Coils Acceptance Review for MQXFA07b and MQXFA11

US-HiLumi-doc-4224

Date: 10/27/2021

US HL-LHC Accelerator Upgrade Project

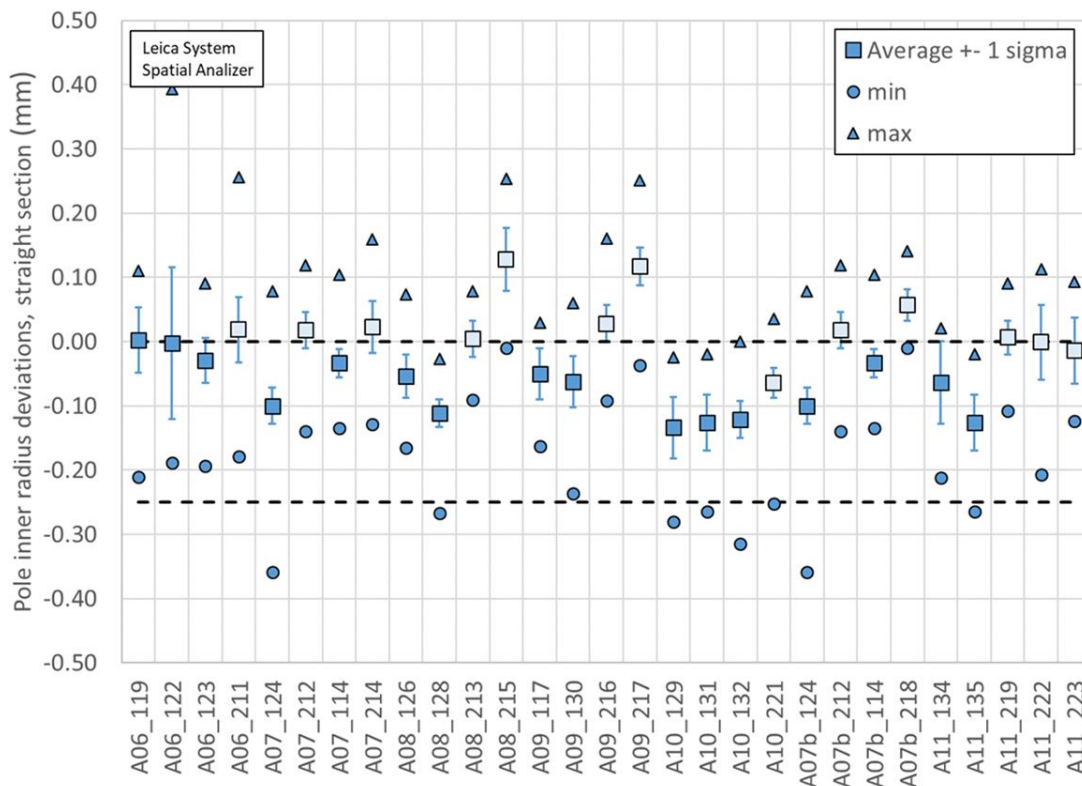
Coil Dimensions: The "Pole" inner radius deviations (greater than maximum allowed value) in the straight section were recorded for nearly all the coils (see plot below as shown at the review). Corrective action: The coil bumper thickness needs to be corrected to compensate during magnet assembly.

Inner Radius coil deviations (excess material) are observed for coil 218, 219, 222 and 223. Coil bumper thickness is to be corrected to compensate. It appears that previous BNL coils have exhibited similar behavior – Coil 215, 216 and 217.
